YN ERWM Comments on Remedial Investigation/Feasibility Study for the 100-NR-1 and 100-NR-2 Operable Units (DOE/RL-2012-15, Rev. 0 Draft, 2023)

Subject: Review of the Proposed Plan and Remedial Investigation/Feasibility Study for the 100-NR-1 and 100-NR-2 Operable Units (DOE/RL-2012-15, Draft A) and Propose Plan (DOE/RL-2012-68, Draft A).

Figure 1. Groundwater Sr-90 Concentration at Wells 199-N-186 and 199-N-67. Source: HEIS.

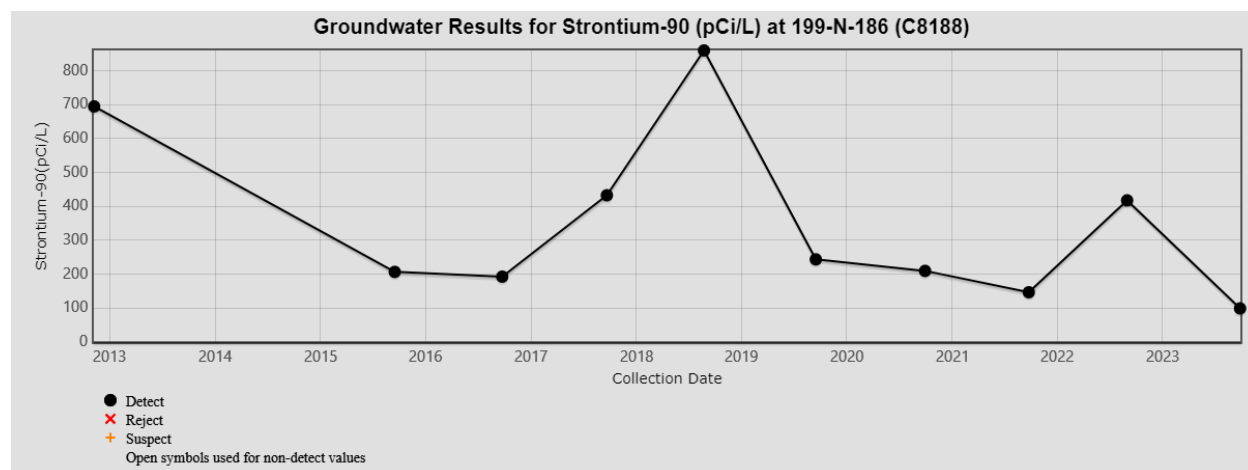
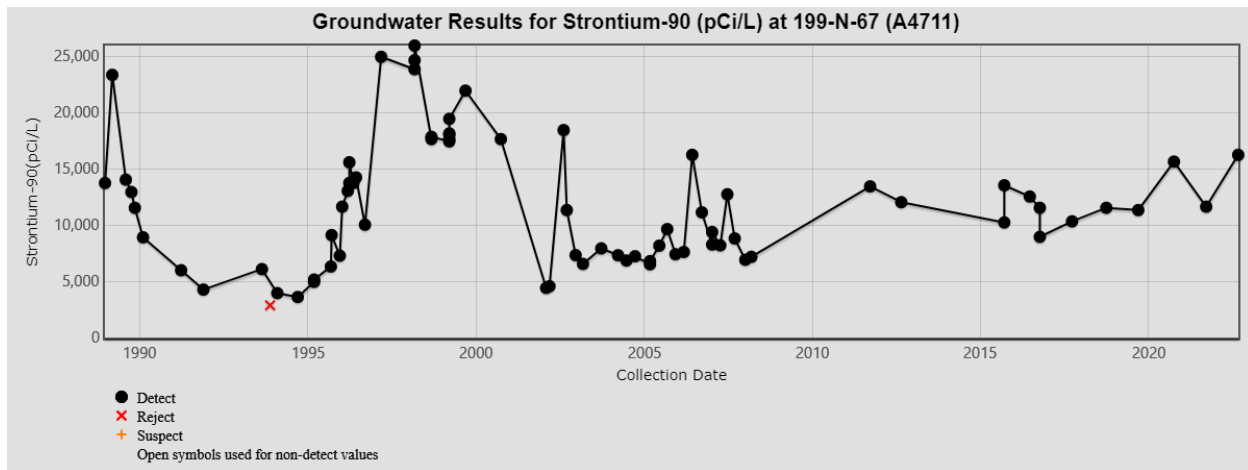
By using the three-layer model, the report (CVP-2006-00004, Rev. 1, 2009) concludes that radionuclides except for tritium in the soil of this site would not reach groundwater in 1,000 years. However, the monitored groundwater Sr-90 concentrations below (Well 199-N-186) and downgradient (199-N-67) of this site indicate continuing sources from the vadose zone (Figure 1 below). The citation to report CVP-2006-00004 (Rev. 1, 2009) should be modified based on the recent data with discussions on why the monitored data contradict the model results.

Figure 2. Groundwater Sr-90 Concentration at Well 199-N-188. Source: HEIS.

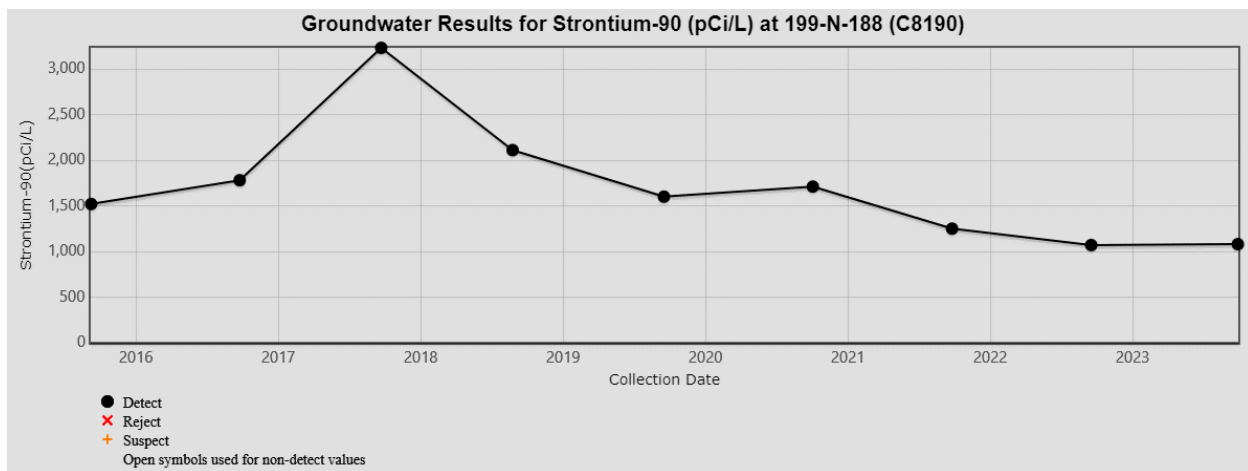
The conclusion of soil cleanup for groundwater protection was based on a method that ignored the high concentration points from the post-remediation verification sampling and used the deeper part of pre-remediation sampling data from borehole 199-N-109A. As described in the last comment, radionuclides might have been mobilized to deeper zones post well drilling, and the original deeper part of the sampling data from the borehole 199-N-109A may not reflect the post-remediation field condition any more. The high groundwater Sr-90 concentration at well 199-N-188 (located within the 116-N-3 extent) (Figure 2 below) is proof that the results of the interim closure of the 116-N-3 site were based on wrong information or the wrong method. The citations to the report (CVP-2002-00002, Rev. 0, 2002) should be modified to include discussions on why the monitored data contradict the model results.

Figure 3. Groundwater Cr(VI) Concentration at Well 199-N-80. Source: HEIS.

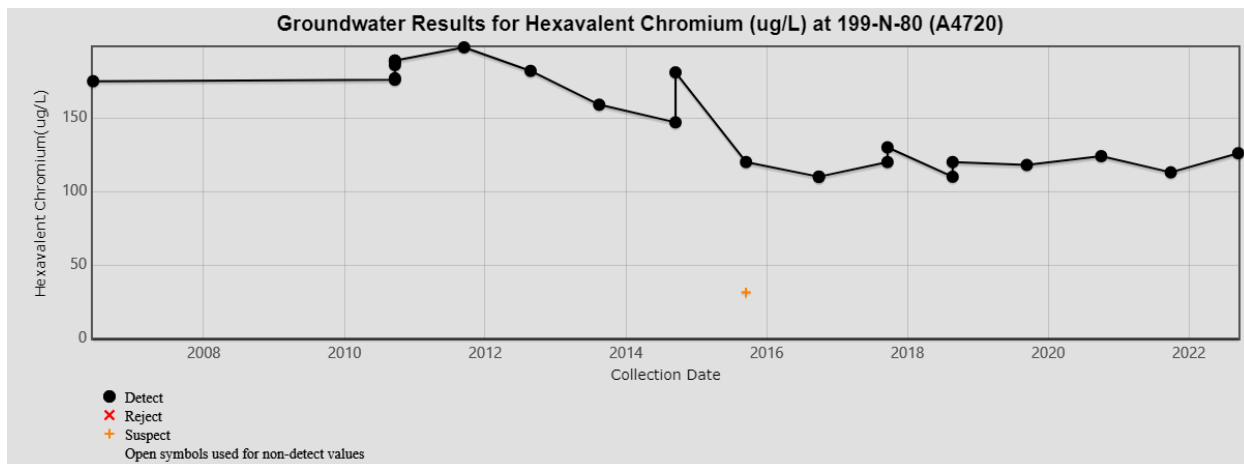
The Cr(VI) concentration at RUM Well 199-N-80 had reached nearly 200 µg/L in 2011, and has been above 100 µg/L since 2006 (Figure 3 below). High hydraulic head in the unconfined aquifer is only one of the reasons causing the high Cr(VI) concentration at Well 199-N-80. If the Cr(VI) concentration in the confined RUM water-bearing zone reached 200 µg/L at some time, the Cr(VI) concentration in the source (the discharge) and the groundwater mound that spread through portions of the current vadose zone and the unconfined aquifer upgradient of the confined aquifer should have also reached 200 µg/L or higher for a period of time, considering the plume attenuation as it migrates downgradient. The maximum Cr(VI)

concentration monitored at Well 199-N-67 shown in Figure 4-103 (of the report) is much lower than that from the RUM well. Have Cr(VI) concentrations of ≥ 200 $\mu\text{g/L}$ been observed at any of the unconfined aquifer wells near Well 199-N-80 or between this well and the 116-N-1 waste site?

Figure 8-18. Strontium-90 Data for Performance Monitoring Wells Along the Central Segment of the Apatite PRB

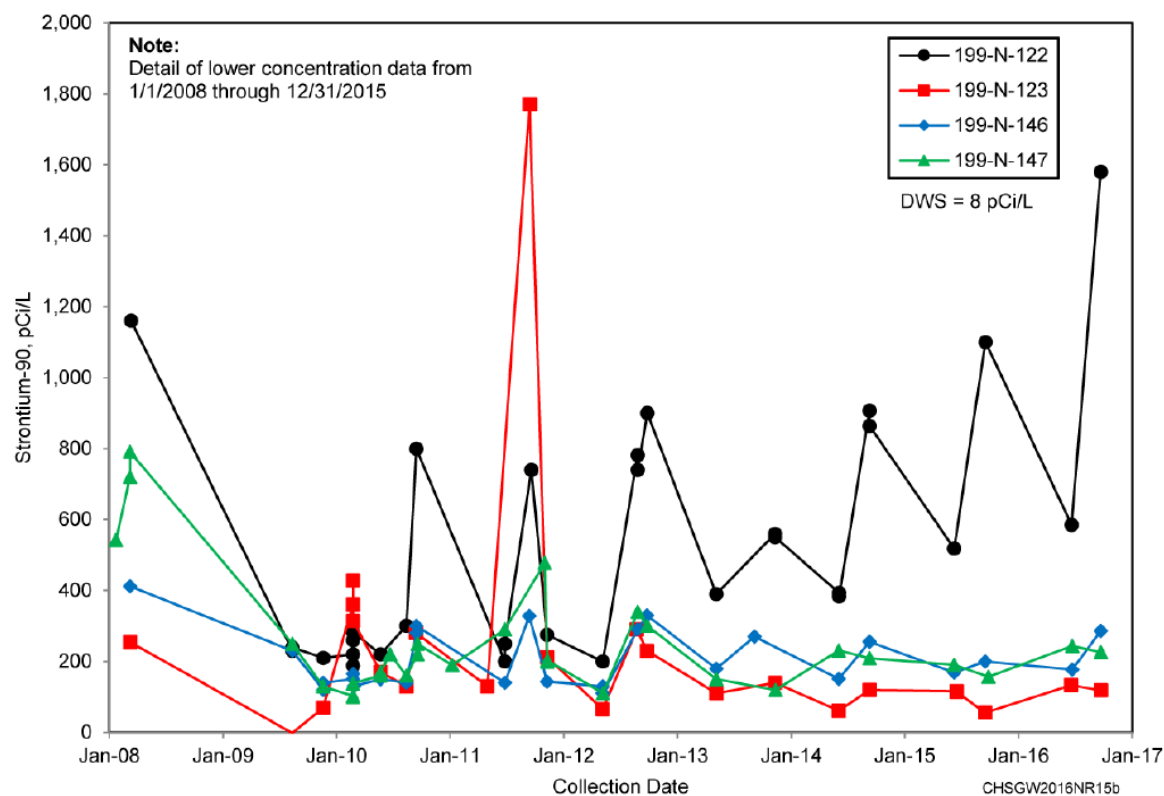
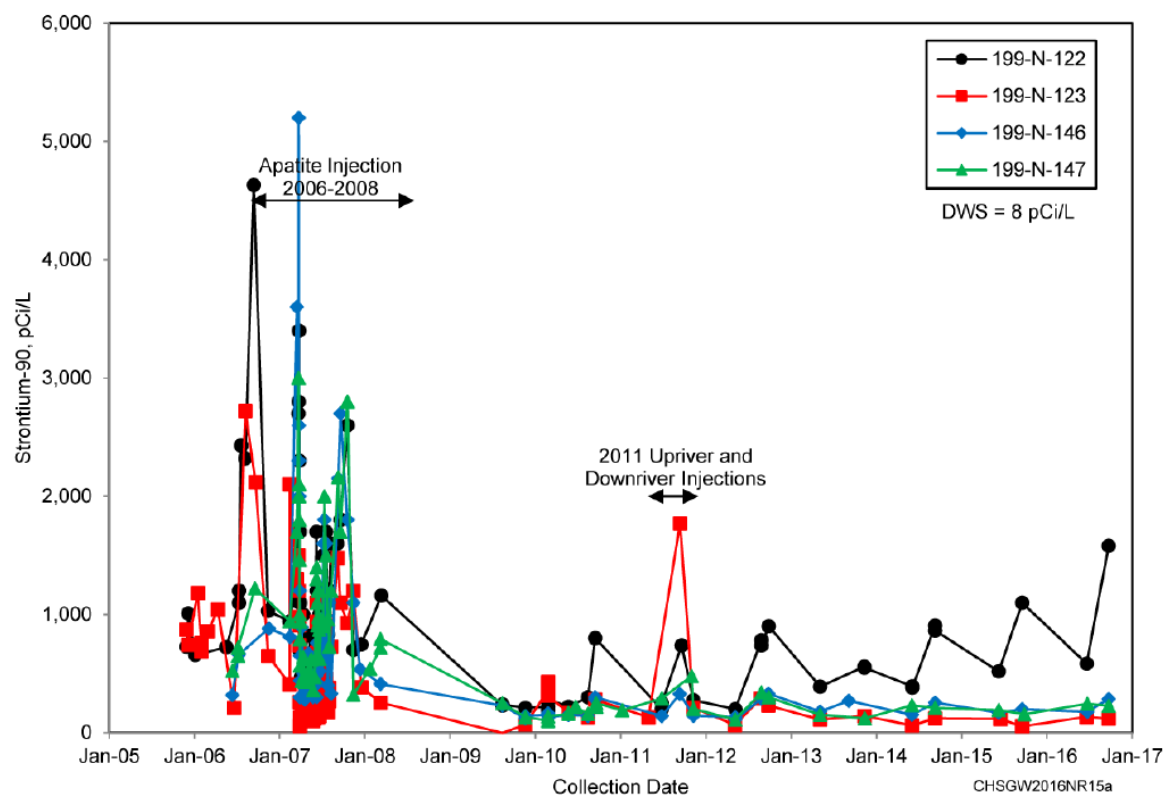
14. Page 4-263, Lines 21–23. §4.5.2. “However, aluminum, chloride, chromium, cobalt, copper, iron, lead, manganese, nickel, silver, strontium, and zinc exceeded their associated drinking water standards or water quality levels in some wells within the apatite treatment zone (some by several

orders of magnitude).” Arsenic and Sr-90 concentration also exceeded the drinking water standards (10 µg/L and 8 pCi/L for arsenic and Sr-90, respectively) in many aquifer tubes and groundwater wells due to the apatite injection (e.g., Figure 4 below for arsenic and Figure 8-18 from this report for Sr-90). Please note that some data points in the arsenic plots are marked as “Non-detect” due to high practical quantitation limits (PQLs) of the analyses methods. Please add arsenic and Sr-90 to the list.

Figure 5. Groundwater Cr(VI) Concentration at 199-N-80 Showing Sampling Season. Source: HEIS.

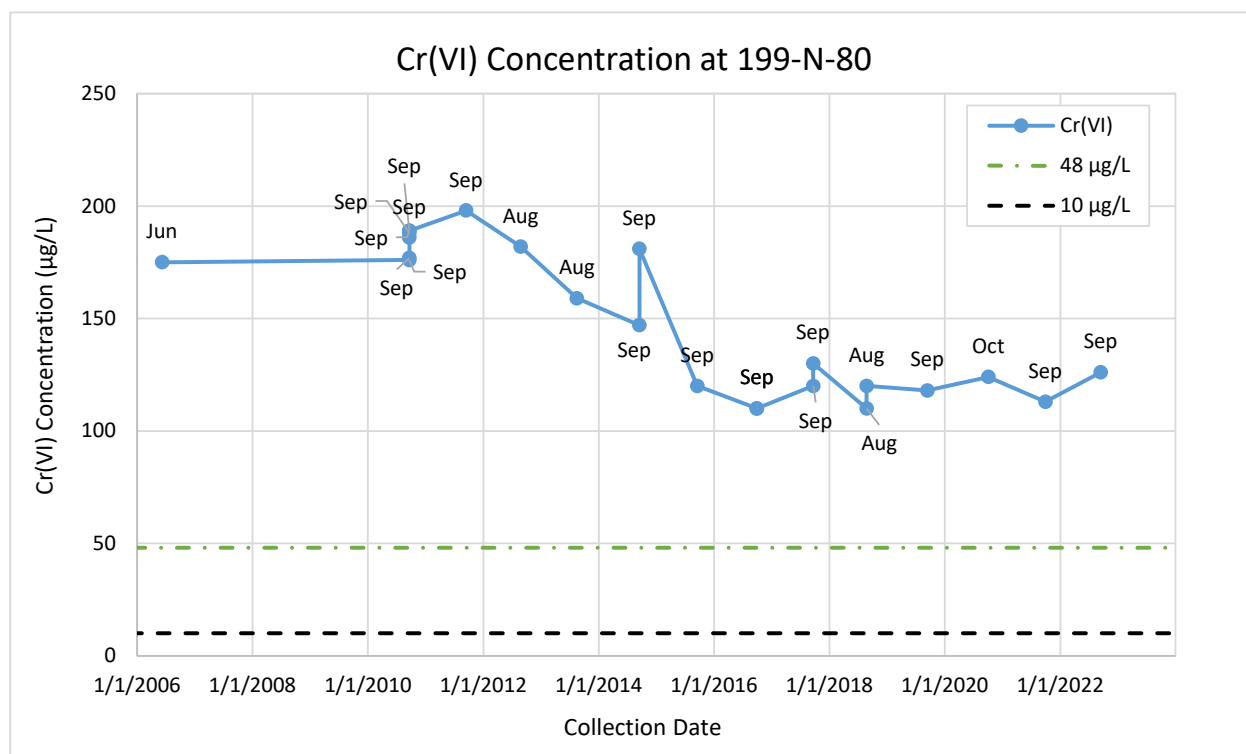
28. Page 8-14, Lines 16–17, §8.1.1.4.1. “Concentration trends at well 199-N-80 are stable and not influenced by river stage effects, unlike nearby monitoring wells in the unconfined aquifer.” The well was only sampled for Cr(VI) once outside the low river stage season (June 2006). Since 2010, Well 199-N-80 has only been sampled for Cr(VI) during low river stage period (August through October each year) (Figure 5 below). Please present evidence to support the statement that Cr(VI) at this well is not influenced by river stage effects.

Figure 8-4. Concentration Trend Comparison for Well 199-N-80 to Unconfined Aquifer Wells 199-N-2 and 199-N-103A

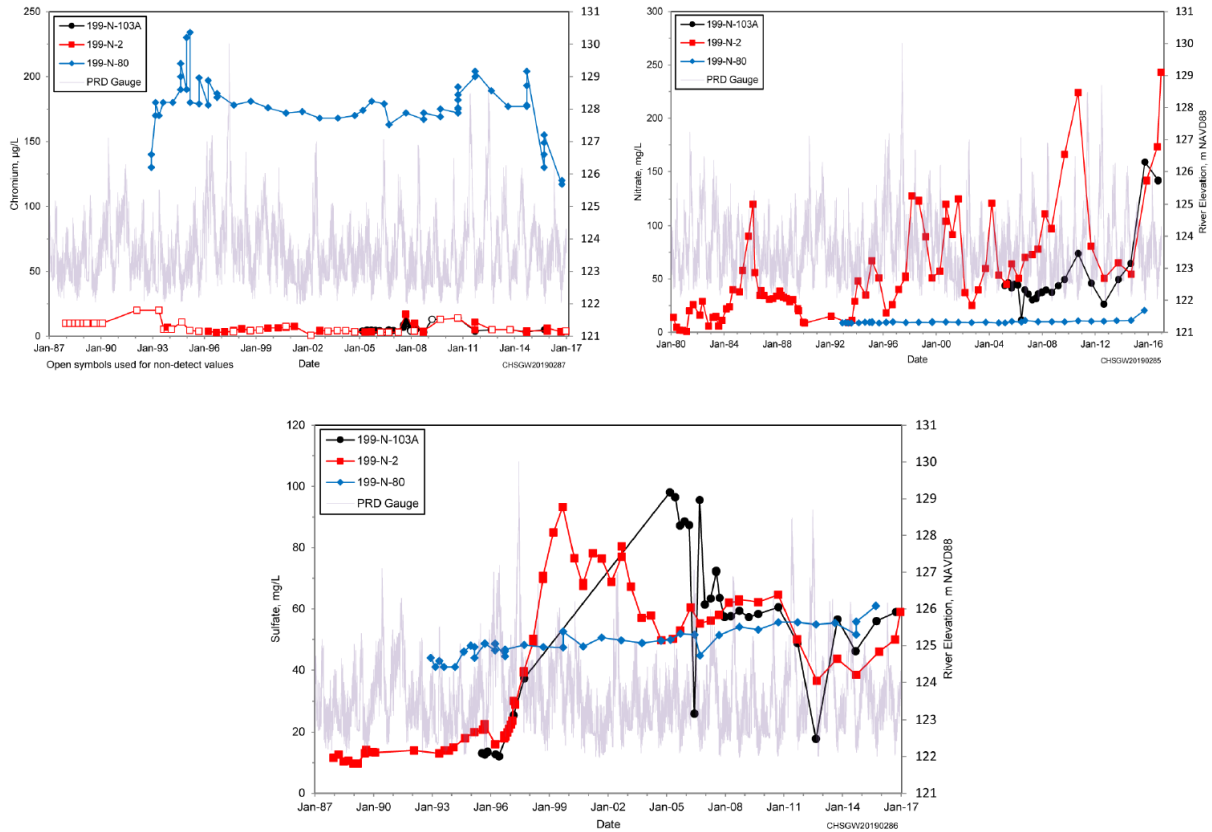
29. Page 8-14. Lines 25–26. §8.1.1.4.1. “Additionally, the observed river-stage effect on nitrate and sulfate concentrations in unconfined aquifer wells 199-N-2 and 199-N-103A does not occur at well 199-N-80.” It is hard to see from Figure 8-4 of this report what effect the river-stage has on nitrate and sulfate concentrations. As shown in Figure 6, peaks of nitrate concentration at 199-N-2 occurred in February (1995), March (1986, 1998, 2004), September (2000, 2001, 2010), and December (2016); and the nitrate concentration in September varied from a high of 224 mg/L on 9/16/2010 to a low of 50 mg/L on 9/7/2012, all in September. Please clarify what the observed river-stage effect is.
